Permit record for 18-0545

3-19-18 HRC Permit Review, Findings:

Windows 18th Ave se project

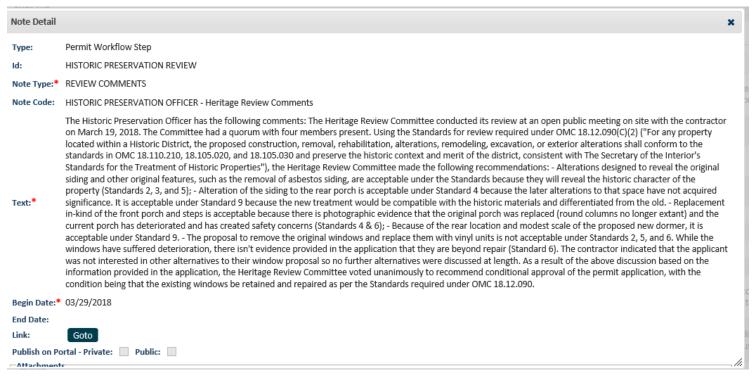
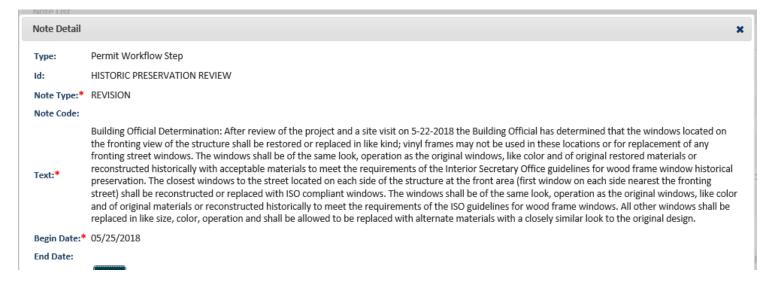
After careful consideration of all issues and the events that have taken place related to discoveries during construction activity of needed repairs and rotting conditions; the permit condition related to the two fronting windows has been revised to read as follows:

"The applicant may replace the two fronting windows facing 18th Avenue left and right to the proposed Anderson historically reproduced windows i.e wood with fiberglass cladding. The windows shall be similar in character and operation and shall not be modified in size. The original color including the white trim piece which crosses the center at a horizontal design shall be maintained" (ref. pictures attached).
